SERVICE ADVISORY

NO.: 23033 Rev C

TO: Garmin GTX[™] 345/345R/345D/345DR/45R, GDL® 88(H)/84(H), GNX[™] 375,

SUBJECT: ADS-B In Surface Targets
REVISION C: Corrected Product Affected

Figure 1 - Example Traffic Display

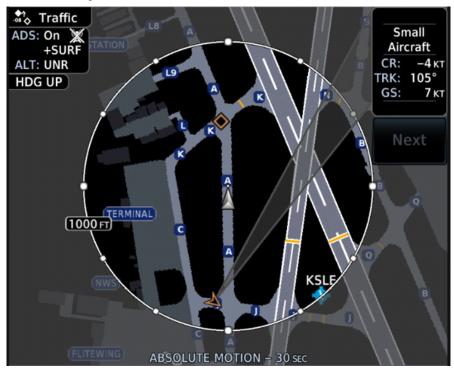
Slow-moving (less than 20 knots) 1090ES ADS-B and ADS-R surface targets may erroneously appear as directional. Figure 1 shows an example traffic display with both slow-moving directional and non-directional surface traffic. The selected surface target is erroneously shown with a directional symbol while the surface target near the top is correctly shown with a non-directional symbol (diamond).

Refer to Table 2.

Unit	Corrected Software Versions
GTX 345DR	ADS-B 3.32 (Garmin TSO Service Bulletin 23042)
GTX 345/345R/345D/345DR/45R	ADS-B 3.41 (Garmin TSO Service Bulletin 23031)
GTX 345/345R/345D/345DR/45R	ADS-B 3.15
GNX 375	Main 3.21 (Garmin TSO Service Bulletin 23037)
GTS 825/855/8000	4.03.1 4.05 (Garmin TSO Service Bulletin 24010)
GTS 800/820/850	5.02
GDL 84(H)/88(H)	3.43 (Garmin TSO Service Bulletin 23056)
